VERMONT YANKEE NUCLEAR POWER CORPORATION

Subject: IE Information Notice 86-13

IE INFORMATION NOTICE NO. 86-13: STANDBY LIQUID CONTROL SYSTEM SQUIB VALVES
FAILURE TO FIRE

1. Squib Schematic
2. List of Recently Issued IE Information Notices

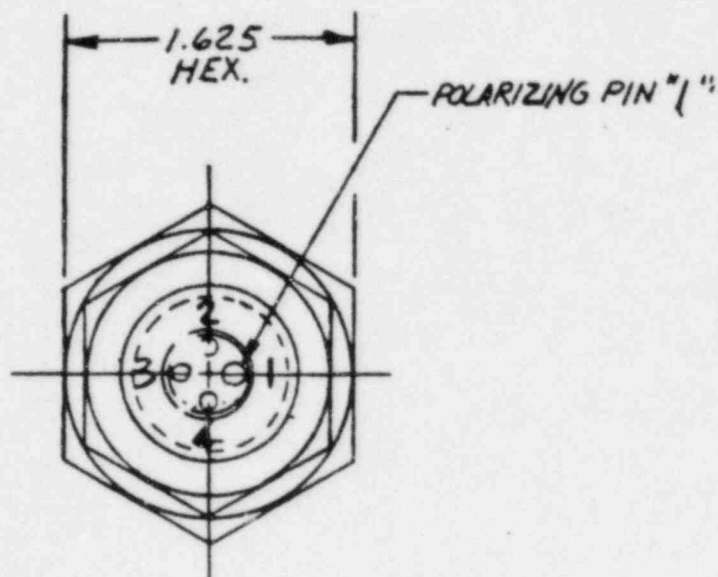
Insert 1 → ~~The squibs are connected to the plant's wiring via four pin connectors. Incorrect wiring at the Vermont Yankee local terminal box resulted in the sequence around the connector being high, high, neutral, neutral. If the wiring in the terminal box had been according to the design drawing and had been high, neutral, high, neutral, the squib charge would have fired even~~

though the pin-to-bridgewire connection was incorrect. (See Attachment 1.) In addition, at Vermont Yankee the control room indication of SLCS circuit status indicated circuit continuity due to the presence of a sneak curcuit.

The squibs are connected to the plants wiring via four pin connectors. Vermont Yankee wired the connectors into the firing circuit as shown in the details of General Electric SIL 186. The SIL did not specify or give any guidance as to the orders in which the wires should be connected, only that each charging coil must have a hot and a neutral across its terminals. Vermont Yankee had it wired as described and such that the firing circuit as well as the continuity circuit would function properly given the correctly wired squib valve.
